# UNITED STATES PATENT AND TRADEMARK OFFICE

10/574,096

Yasutsugu Muranishi

# Office Action Summary

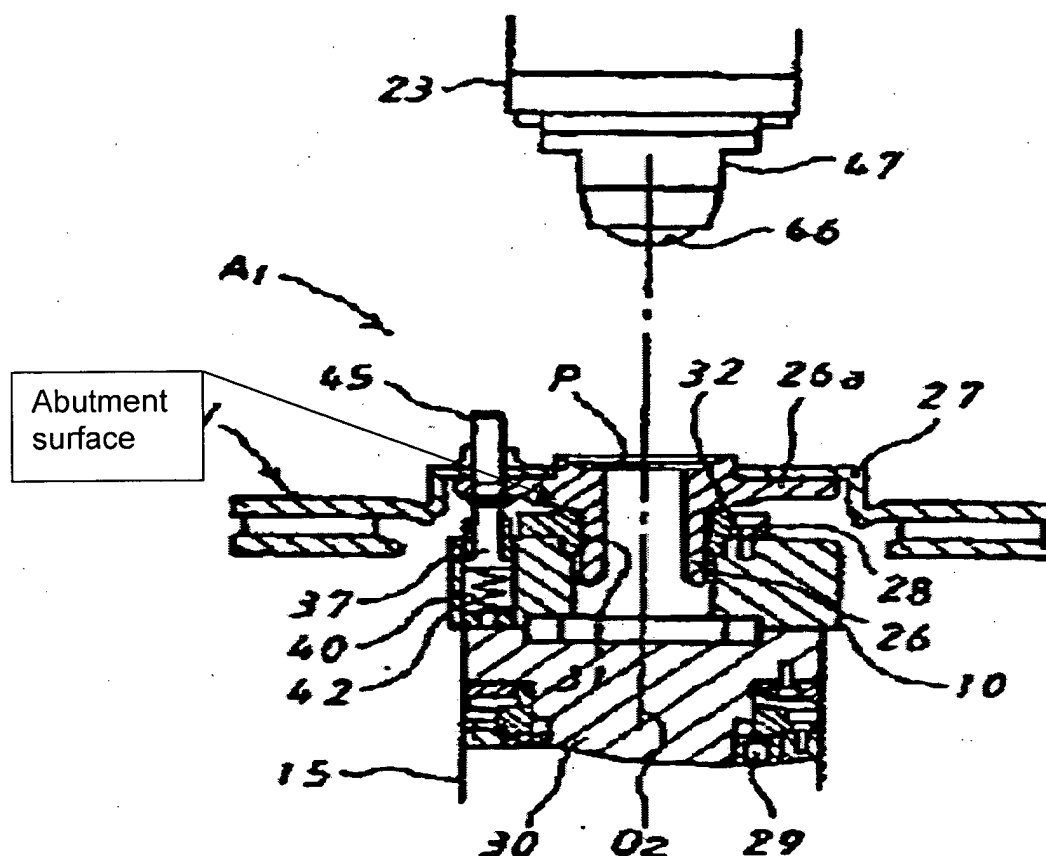
7. Claims 1-6 are rejected under 35 U.S.C. 103(a) as being unpatentable over Akiyoshi (JP-2004/050334) in view of Katsumi (cited by applicant). Akiyoshi clearly discloses the structural elements as claimed by the applicant, which includes a vertical duplex-head surface comprising, a work holding portion (10) including a first reference plane (31) coaxial with a self-rotating shaft (O2) and a second reference plane (32) perpendicular to the self-rotating shaft, the apparatus further includes upper and lower grindstones (2 and 3) and a clamping device (12) having a steel ball (23), but lacks, a method for dressing the above mentioned grindstones with a dressing tool including a fitting portion/cylindrical member designed to fit within the first reference plane and an abutment surface designed to abut against the second reference plane. However, Katsumi teaches of a method for dressing two vertically opposing grindstones with a dressing tool that can be formed with the same configuration as the work (see below), meaning that the shape of the dresser can be the same as the work.
